CASE # C15-2012-0120
ROW # 10827078

**CITY OF AUSTIN
APPLICATION TO BOARD OF ADJUSTMENT
GENERAL VARIANCE/PARKING VARIANCE**

STREET ADDRESS: 1704 Karen Ave, Austin 78757

CITY OF AUSTIN – PLANNING AND DEVELOPMENT REVIEW DEPARTMENT
RESIDENTIAL PLAN REVIEW APPLICATION – MASTER COMMENT REPORT

1704 KAREN AVE., AUSTIN, TX 78757
 LOT 7, BLK G, BRENTWOOD TERRACE
 504 PLAN
 Modified for Ordinance Compliance

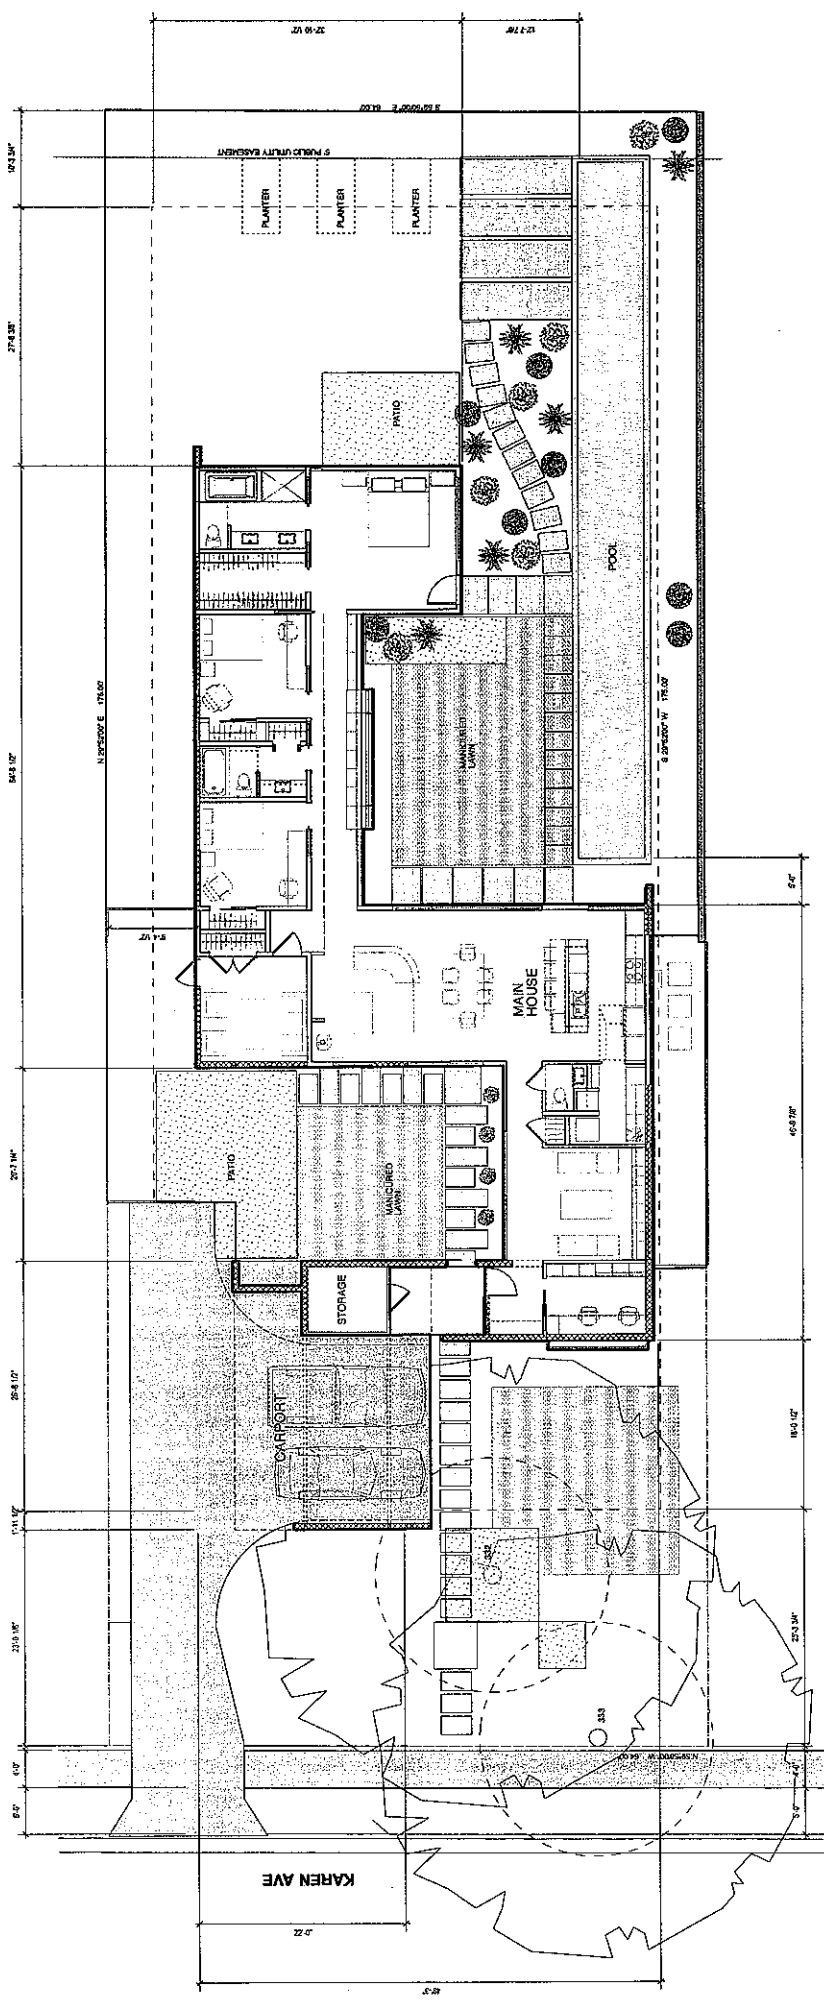
1. This site will need a tree permit. This can be facilitated on the 4th floor.
2. This property is located within 150 feet of a FEMA floodplain and will need to be reviewed in the floodplain office. This is an internal review. No action from applicant is needed for this review at this time.
3. The carport placement at the front violates LDC 25-2-1604 (Garage Placement); The Brentwood Neighborhood Plan elected to adopt this infill option in May 2012. Unfortunately, the design will need to be altered unless you can meet the wording of the code section. One detail that might be able to get you around the code is that if the entrance of the garage/carport faces any way other than the front lot line, that would be allowed. Not sure if you can rearrange the driveway to make the entrance face the side, but if you can then I believe you will be able to make it work.

II. Modified ('traced') version
 - In this version, the carport is rotated to comply w/ guidelines. However, more pavement is required and parking 2 cars in the structure will be very difficult.

1 Site Plan
 Original Carport Usage

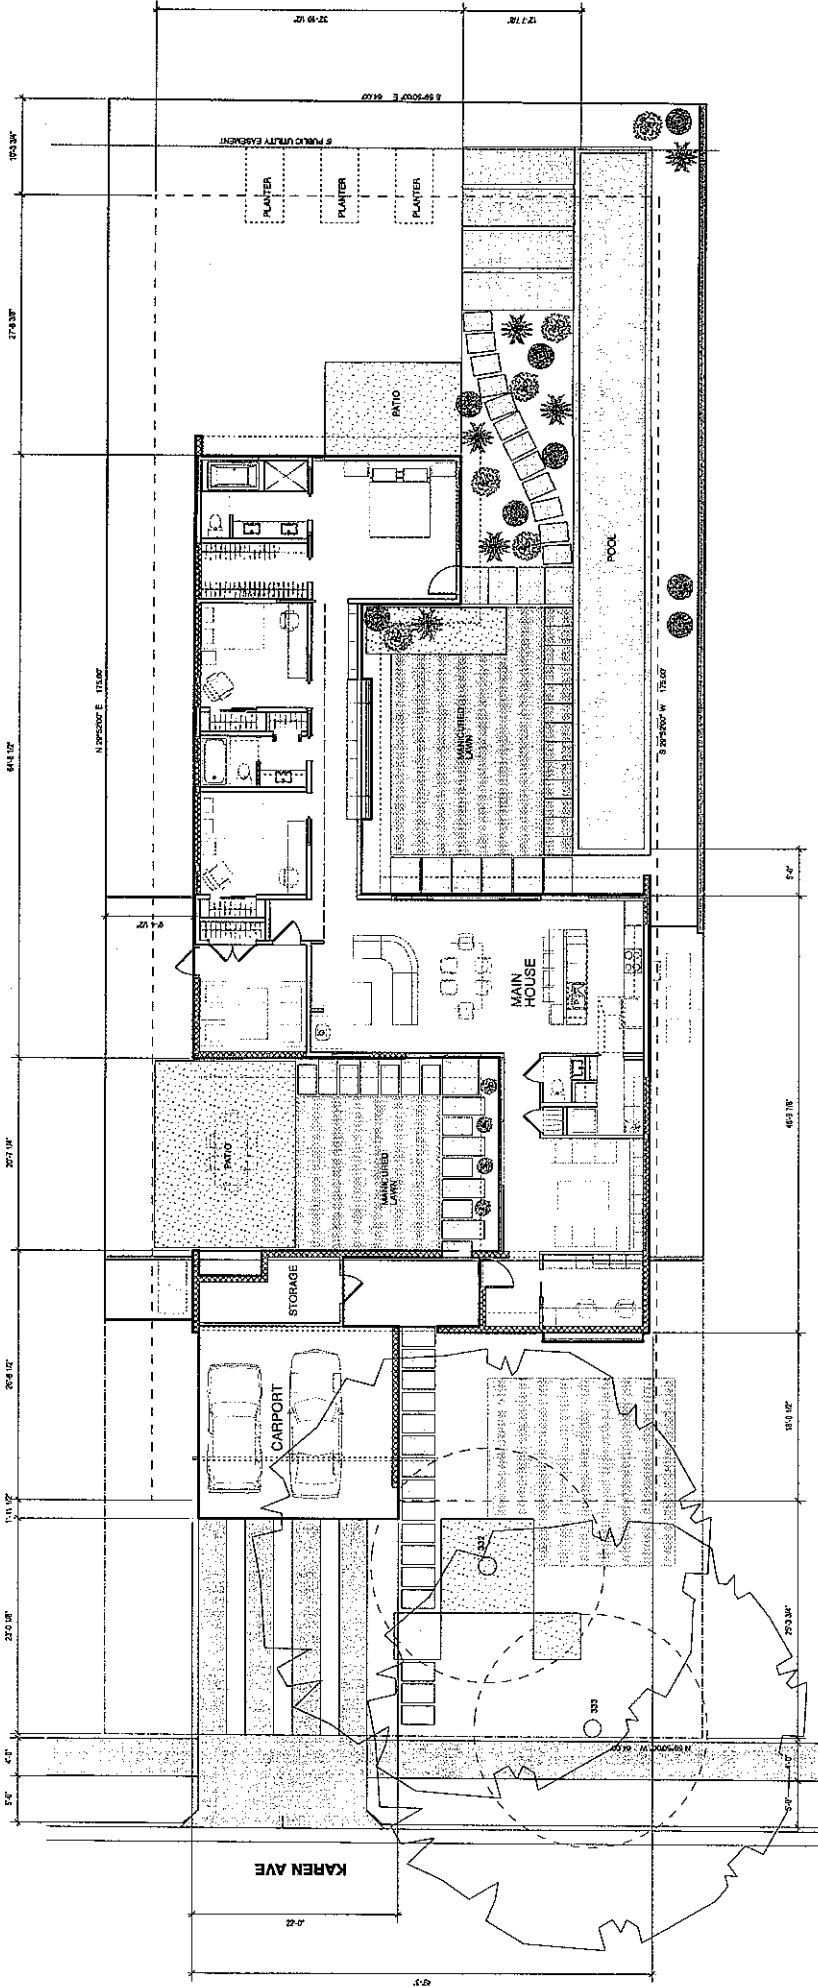
I. ORIGINAL VERSION

— We are requesting consideration of variance so that carport may face the street as indicated below.
